From: David Sellers
Sent: Wednesday, January 15, 2020 7:49 PM
To: Daniel S Imperiale
Cc: Ryan Hoest; Ryan Stroupe (R2S2@pge.com); stanford.rollins@1earth.ws; Knipfing, Isaac
Subject: RE: San Mateo CHW Diagram

Office of San Mateo Phase 1

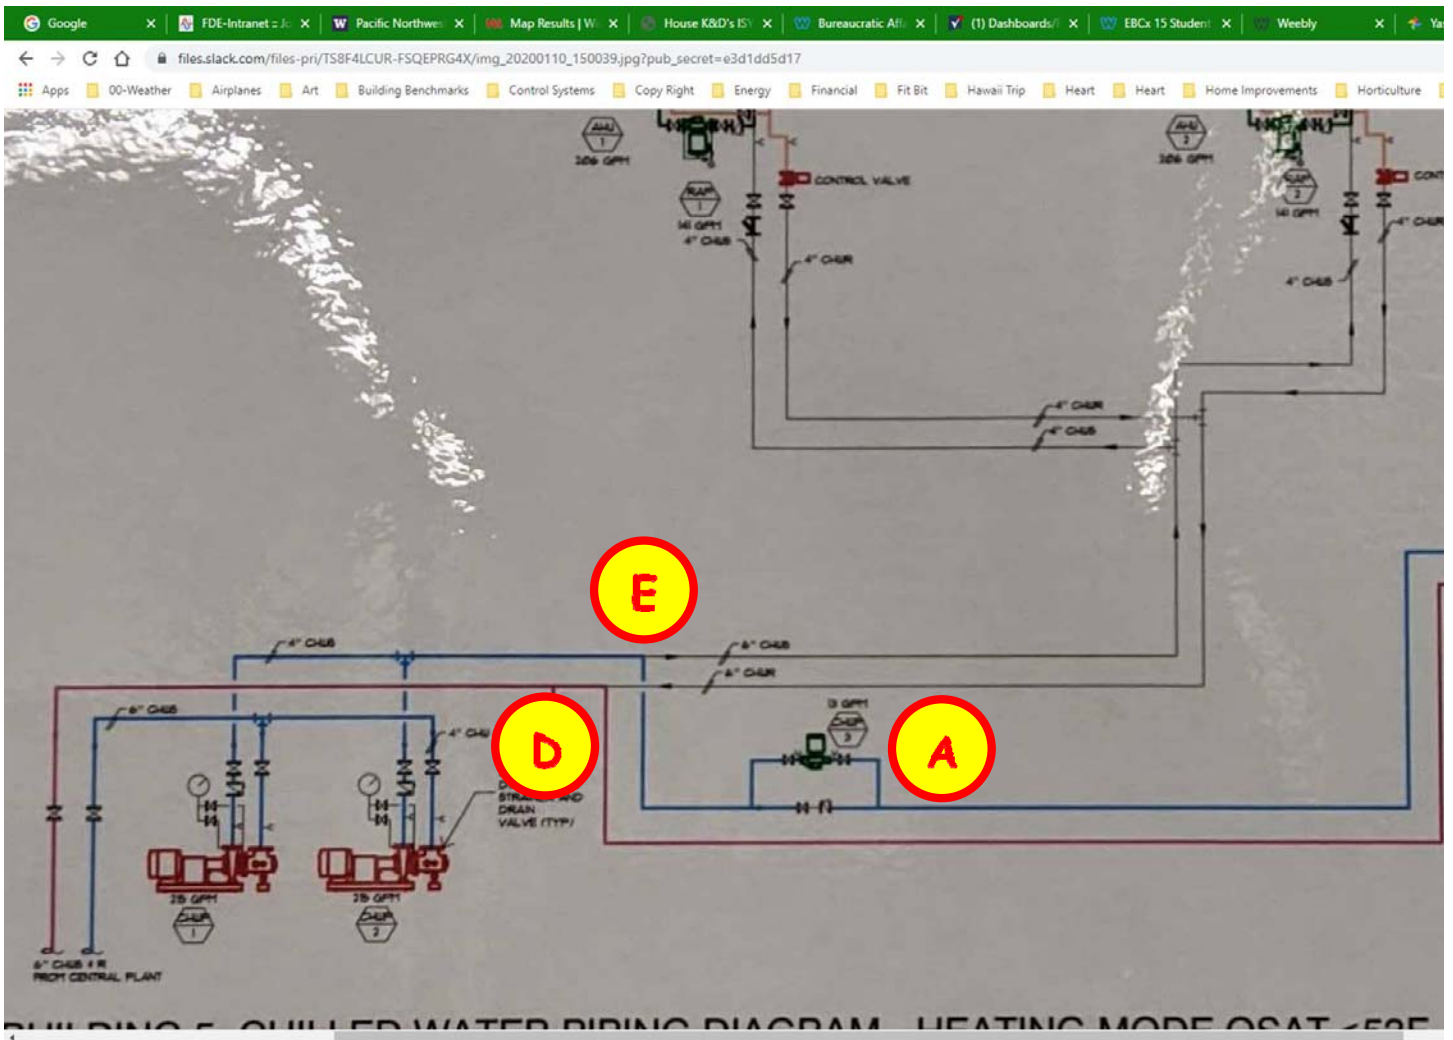
Ryan has asked me to do something with this in an upcoming EBCx class, so I will get into more depth in preparation for that. But for now, with regard to the last bullet point, I realize they might show what you say in their diagram. But sometimes, I have found that what is written down may not be what is actually happening.

In situations like that I try to go back to fundamental principles and in this case, my conclusion is based on conservation of mass as follows.

I should also mention at the end of the day, the building probably was telling us the answer; we (or at least I) forgot to see what it had to say. In other words, if the pipes at the remote location are cold/at or near the CHW supply temperature, then there is flow. If there really is no flow, then the lines would warm up.

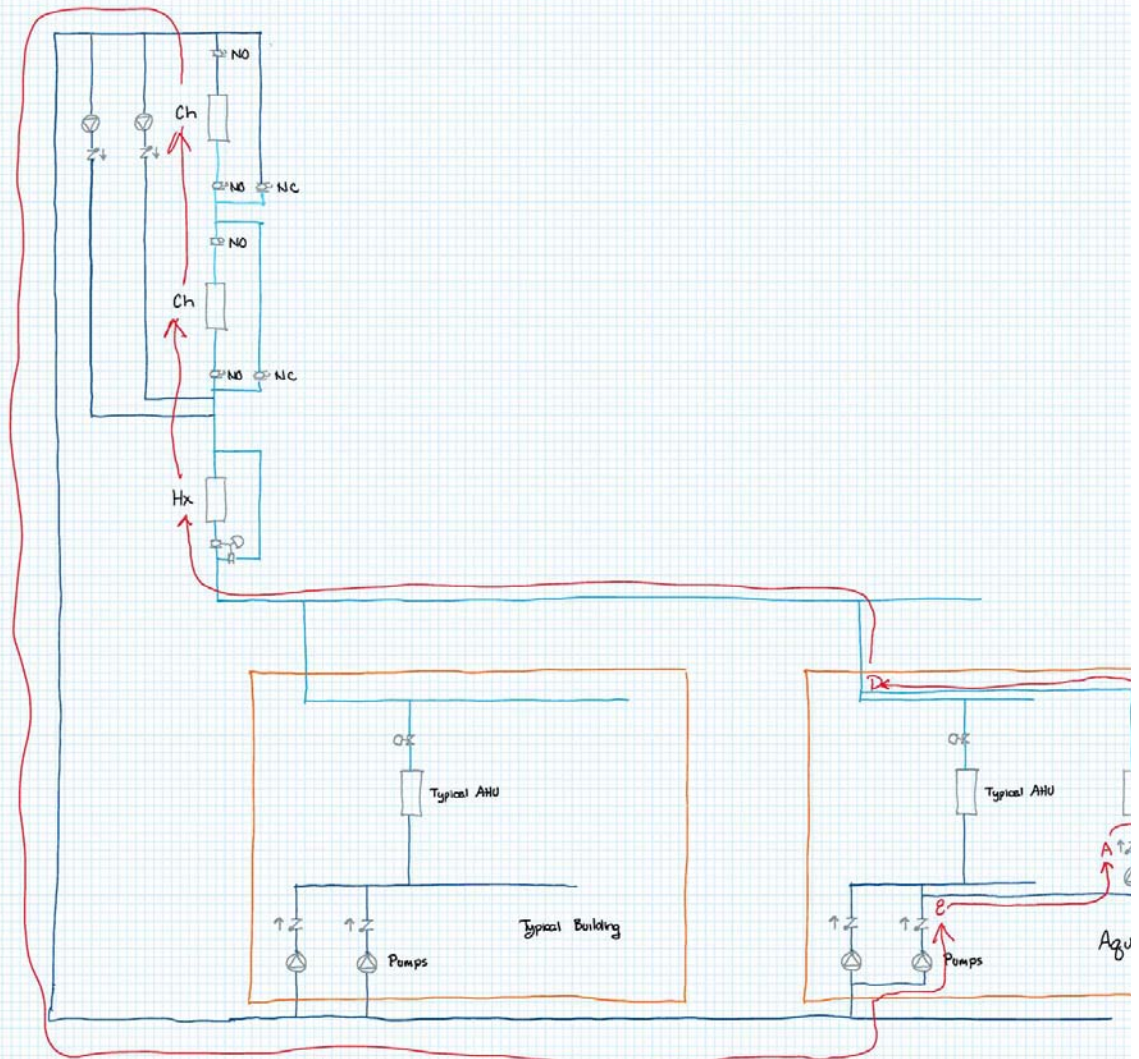
1. If we start at "A" and assume the fan coil unit valve is open and the pump is running, then, if I am thinking about it right, the water would want to flow from A to B to C and then back to the mains at D.

2. To conserve mass, from D, the water would have to get back to E somehow. This is where my diagram might come in handy

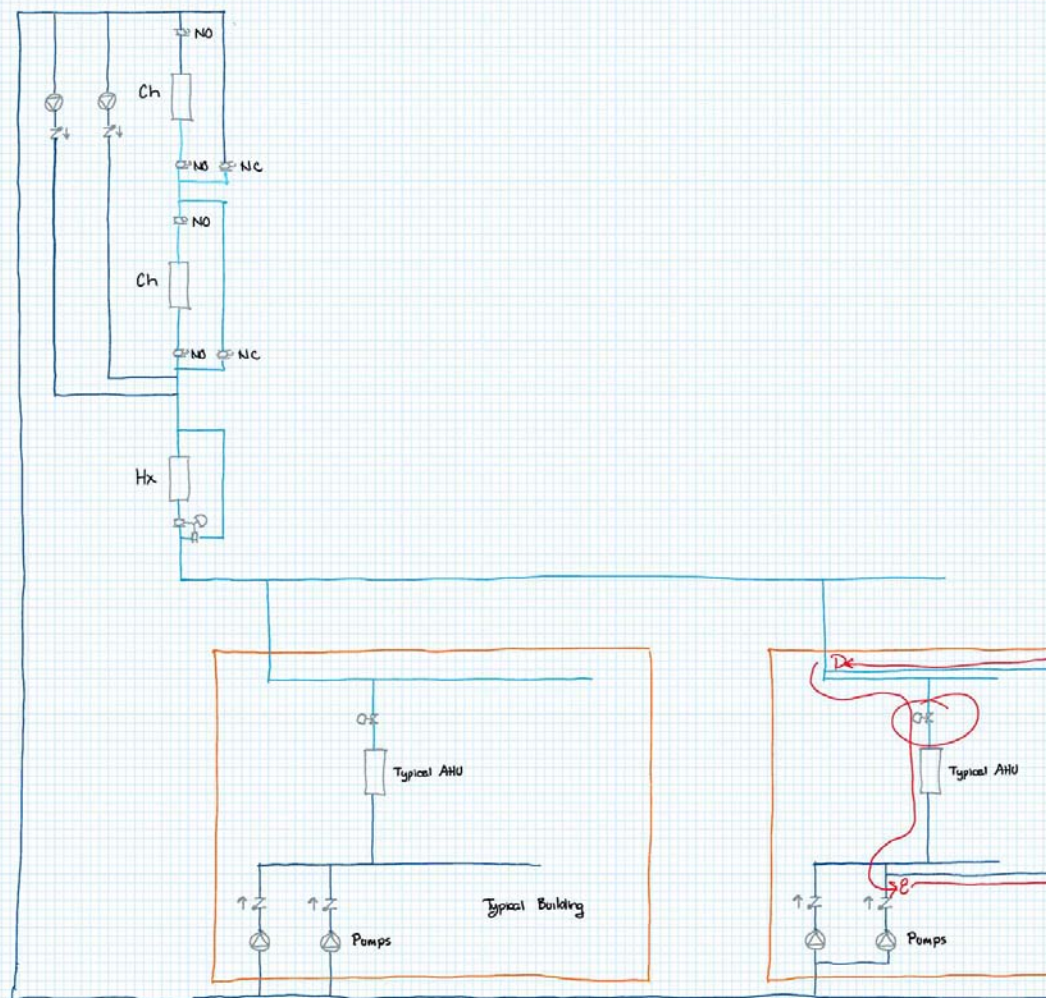
- There are two options I think. One route would be to flow back to the plant, go through the plant and come back as cold water, flow through one or both pumps, lift their check valves, and return to E and then to the booster pump suction and back to A, the booster pump discharge.

That path is not inconceivable, with out the primary pumps running and of course, is the path that would happen if the primary pumps were running.

But with out the primary pumps, it means the booster pump would need to have enough head "compete" with the building pumps in the other buildings if they were running. That is because the booster pump would be in parallel with them through the load and through the aquatic center building pumps. In other words, it's suction connection traces back to the same pipe as the suction connection of the other building pumps, and its discharge connection also traces to the same pipe as the discharge connection of the building pumps.

In addition, it would have to have enough head to lift the check valves on the primary pumps. This is probably less of an issue than competing with other, potentially higher head pumps in parallel with it. But, most check valves rely on more than differential pressure and/or gravity to close in order to ensure that they close before flow reversal happens. That means most of them have springs that force the discs closed. That means that before the valve opens the pump has to generate enough pressure to overcome the spring forces. I believe the spring force is not particularly huge, maybe 0.5 - 1 psig (1-2 ft.w.c.). But it could be a factor for a pump selected for a relatively low head, which is typically what booster pumps are picked to do.

I don't know the booster pump's rating but it would not surprise me if one or the other of the items I just mentioned was a constraint. For instance, if the other building pumps were creating a head of 50 ft.w.c. across the mains to/from the plant, the booster pump would need to have that much head available between D and E to push water into the system along with whatever head it took to move the required flow for the fan coil unit through the circuit it served, which would include the primary pump check valves, pump bodies and piping if the primary pumps were off.

And, if the flow was occurring on this route, then it would go by the flow sensor for the BTU meter, which appeared to be located in the common piping just outside the pump room (kind of where the orange "building" line crosses the dark blue CHW line ahead of the building pumps). So, if there was flow in this line and it was above the cut-in point for the flow meter, then it should have shown up as flow on the meter.
